REMARKS

DRAWING AMENDMENTS:

ANNOTATED MARKED-UP DRAWINGS

FIG. 1

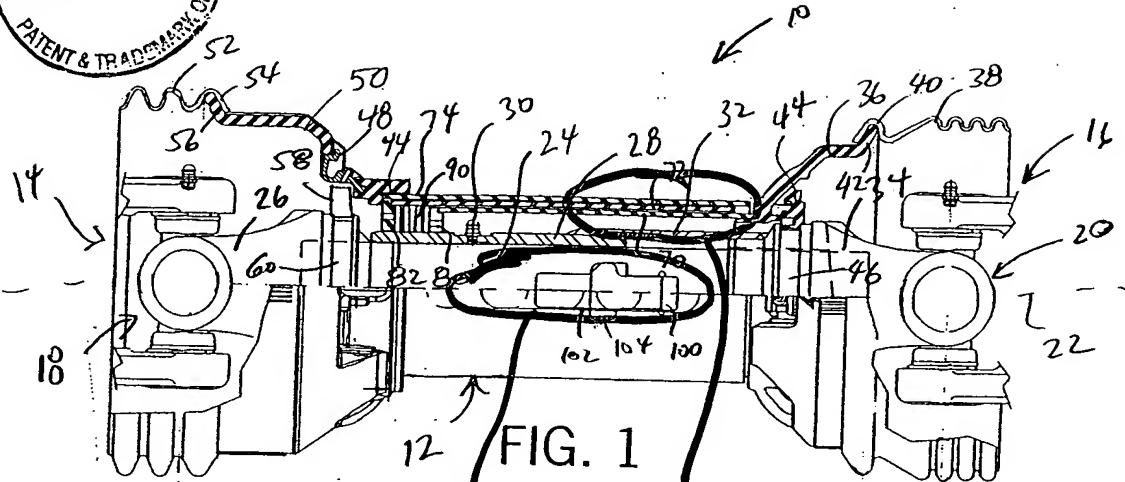
Regarding point 1f, Fig. 1 now shows the tab and slot arrangement of the claims in the same manner as Fig. 2, albeit when the guard is contracted.

clean up

Show tab/slot as in Fig. 2

Show w/
Correct X-hatching
and at increased
scale X 1.5 - X 2

FIG. 2

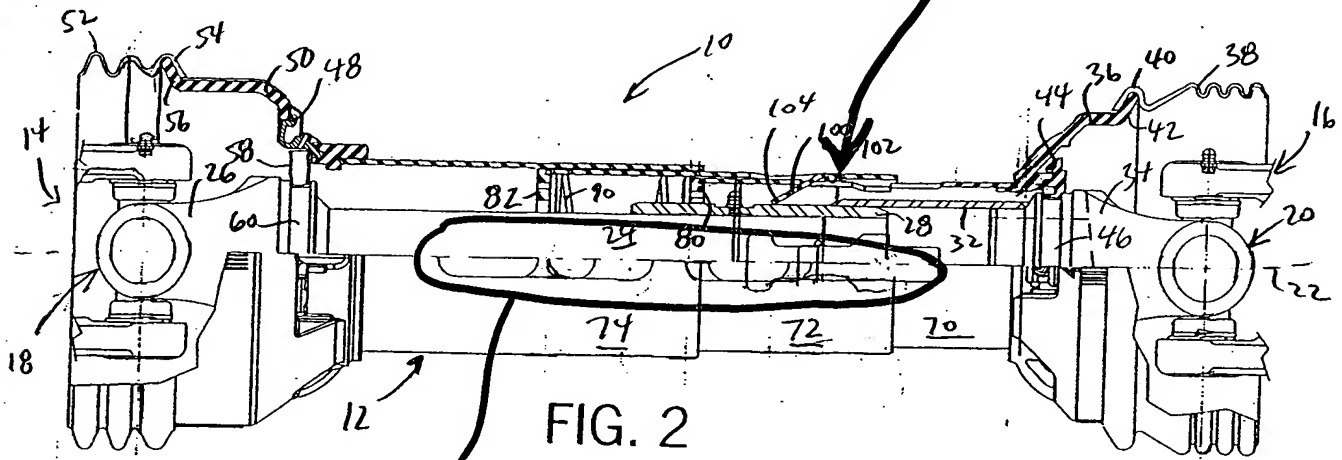
Regarding point 1d, the spring 90 is in fact shown in Fig. 2 biased against the end piece 82 as stated in the specification as represented by the vertical line just to the right of the vertical line defining the right side of the end piece.

clean up
